IEEE P802.11

Wireless Access Method and Physical Layer Specification

**Proposed Text for Sections 5.5 and 5.6,
Based on responses to Draft D1 Letter Ballot processed
at March 1995 Meeting**

Abstract: This paper presents the changes to section 5.5 thru 5.6 in the Draft Standard P802.11/D1 as a result of the Response to Draft D1 Letter Ballot processed at the March 1995 Meeting as shown in the companion Document P802.11-95/70.

Figure 5-24: Fragmentation Near a Dwell Boundary

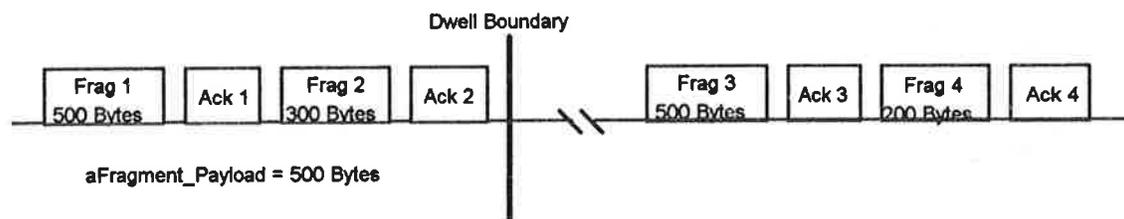
Since the control of the channel will be lost at a dwell time boundary and the station will have to contend for the channel after the dwell boundary, it is required that the acknowledgment of a fragment be transmitted before the stations cross the dwell time boundary. Hence, if there is not enough time remaining in the dwell time to transmit a fragment with an aFragment_Payload payload, the number of octets in the payload may be reduced to the maximum number of octets that will allow the fragment plus the MAC acknowledgment to fit within the time remaining in the dwell time. This is shown in Figure 5-24, for an MSDU of 1500 octets.

Referring to Figure 5-24, a 1500 octet MSDU is fragmented into four fragments with aFragment_Payload set at 500 octets. There is enough time left in the dwell to send two fragments, one of 500 octets and a

second of 300 octets. After the dwell boundary, the rest of the MSDU is sent, one 500 octet fragment and one 200 octet fragment.

Figure 5-25: Fragmented MSDU with missed ACK Near a Dwell Boundary

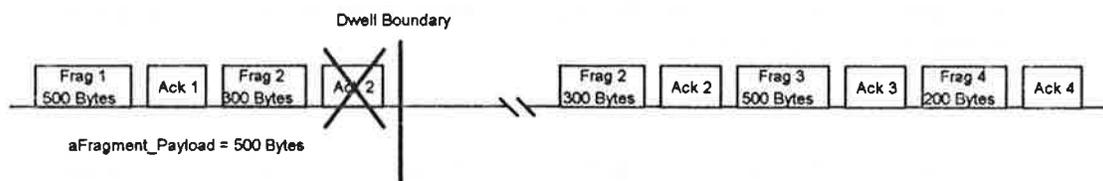
If a fragment requires retransmission, its contents and length shall remain fixed for the lifetime of the MSDU at that station. In other words, after a fragment is transmitted once, contents or length of that fragment are not allowed to fluctuate to accommodate the dwell time boundaries. Let the fragmentation set refer to the contents and length of each of the fragments that make up the MSDU. The fragmentation set is created at a station as soon as the fragments are attempted for the first time. The fragmentation set remains fixed for the lifetime of the packet at the transmitting station. This is shown in Figure 5-25.

In the example shown in Figure 5-25, the same 1500 octet MSDU is fragmented at the same point in the dwell time as in Figure 5-24 but the ACK for the second fragment is missed. After the dwell boundary, the fragment is retransmitted and the fragment size remains 300 octets.
